CERTIFICATE OF APPROPRIATENESS

Property: 716 Arlington Street, Lot 17, Block 257, Houston Heights Subdivision. The property includes a historic 1,387 square foot, one-story wood frame single-family residence and a detached shed situated on a 6,600 square foot (50' x 132') interior lot.

Proposal: Alteration – Construct a 1,374 square foot one and a half story addition and attached garage at the original rear wall of the residence.

716 Arlington Street – Alteration-Addition/Garage

EAST (REAR) ELEVATION

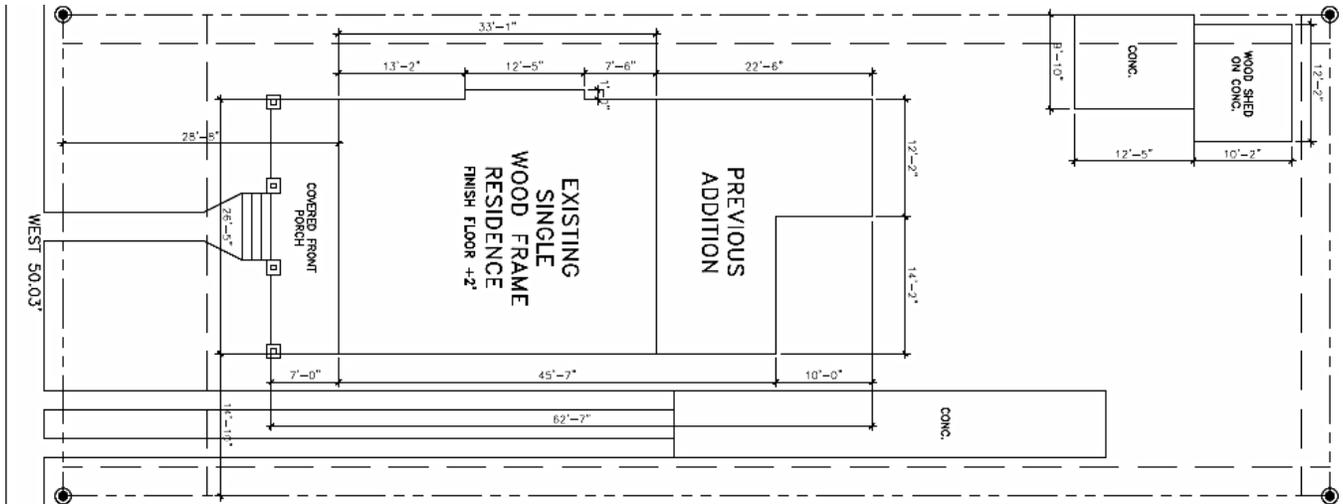
I can SUPPORT WITH CONDITIONS, the proposed one-story addition to the rear of the existing contributing structure. Two proposed modifications warrant additional conditions. First, the applicant proposes to elevate the existing structure an additional 6 inches to a total of 30 inches above natural ground. To accomplish the elevation change, the brick/wood combination columns will need adjustment. I can support this change being accomplished by a foundation addition to the bottom of the exiting brick base that would raise the brick/wood combination column along with the remainder of the house structure so that the front vertical proportion of the elevation would remain constant. The vertical addition at the bottom of the combination columns would have the least negative visual impact when compared to other methods of raising the house structure and not raising the combination columns or adding to the wood portion of the column to increase the height.

Second, the applicant proposes to add side dormers to the addition for additional natural lighting. The visual character of these proposed dormers completes with the simplistic visual character of the existing contributing structure and visually enhances the proposed addition to the detriment of the existing historic structure. I can support this application if the visual impact of the proposed side dormers is reduced.
